SS 1034492 New Cascadia P4 Coolant Level Wiring Damage

All New Cascadia P4 Vehicles manufactured before September 2019

Picture of areas to check for damaged wires Figure 1

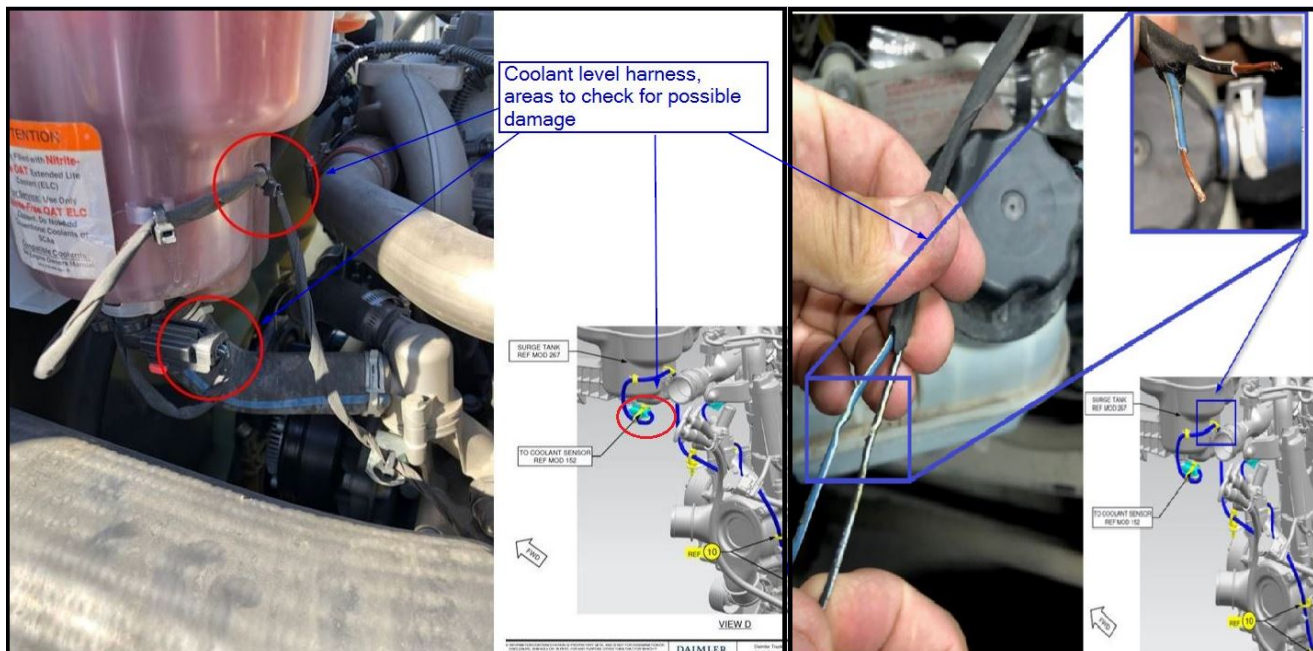
Depending on the tension applied to the wiring located at the coolant level sensor and its mounting locations, wiring damage can occur, resulting in one or more of the above listed codes becoming active. See figure 1 for areas of concern pertaining to the coolant level harness routing.

Cummins routing original vs new Figure 2

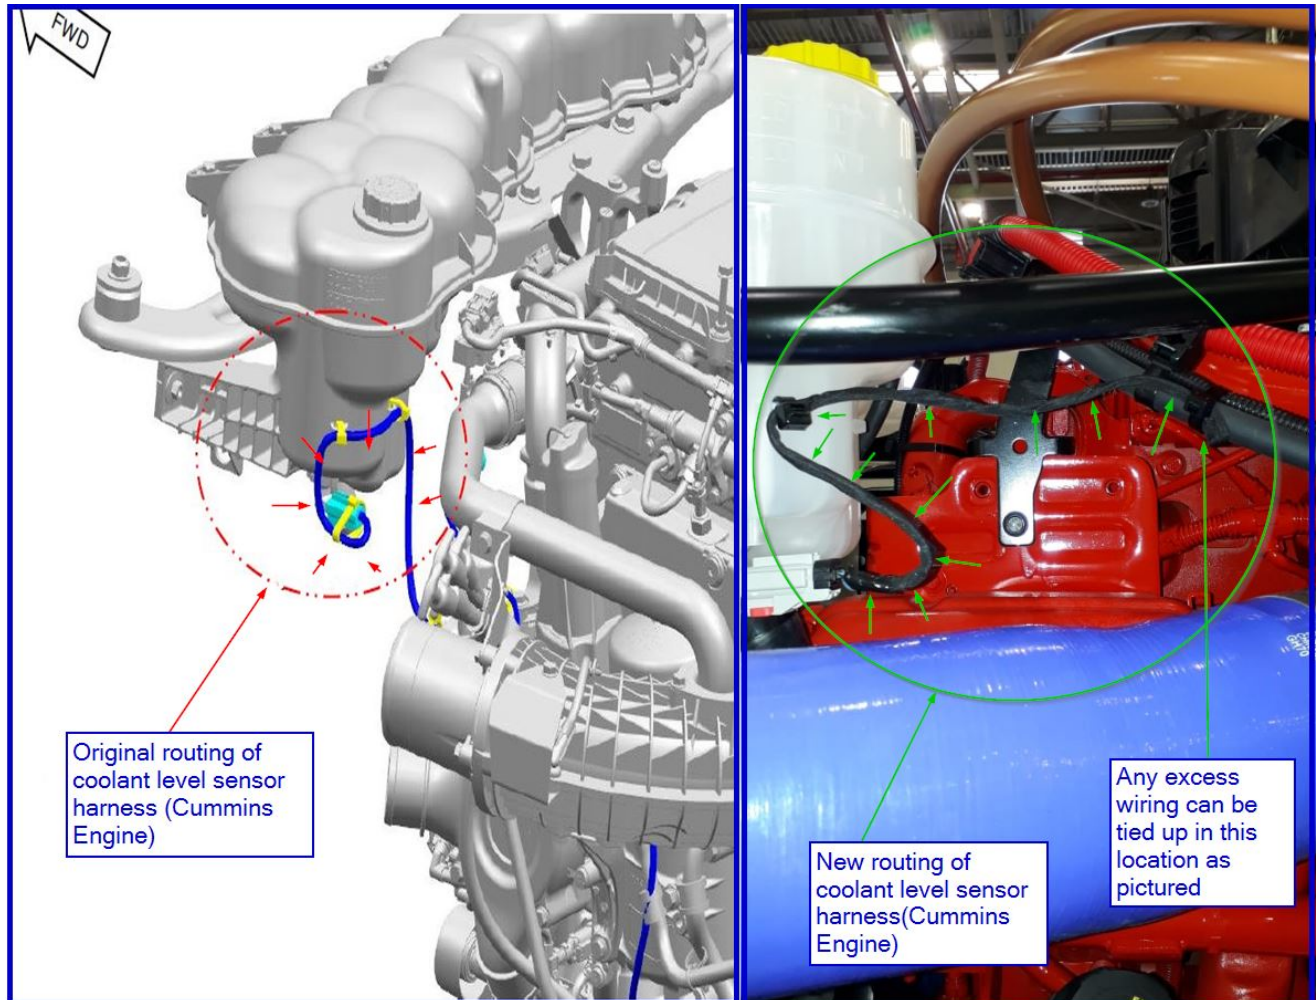
If the coolant level sensor harness is damaged, reference Freightliner Service Bulletin 54-290 for proper repairing of the harness. Once repairs are made to the harness, make sure that harness is properly wrapped with the abrasive tape (part number 48-25910-002) properly protecting the wiring. Route the wiring for HDEP engines referencing the new routing in figure 3 below and for Cummins engines reference figure 2.
